Technical Bulletin

Two & Three Function Pressure Relief and Flow Control Valves

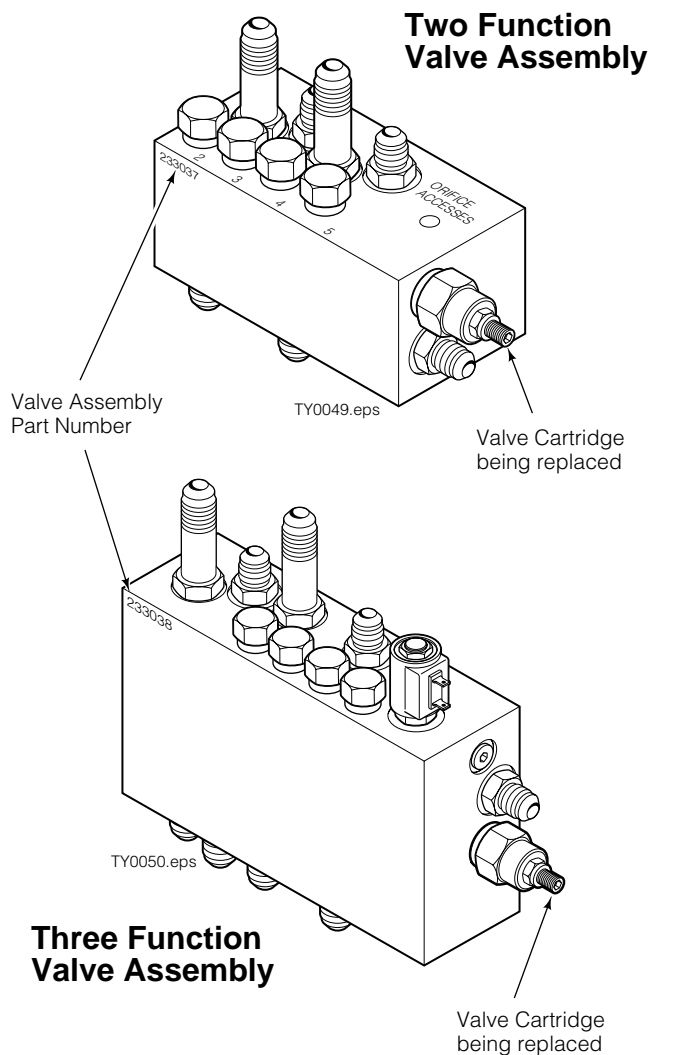
The Two and Three Function Pressure Relief and Flow Control Valves have been updated with a new valve cartridge. The new valve cartridge improves the pressure and flow control function of valve assembly.

Replace the end valve cartridge with new cartridge 6048960. The new valve cartridge is fully interchangeable with the cavity for the old cartridge.
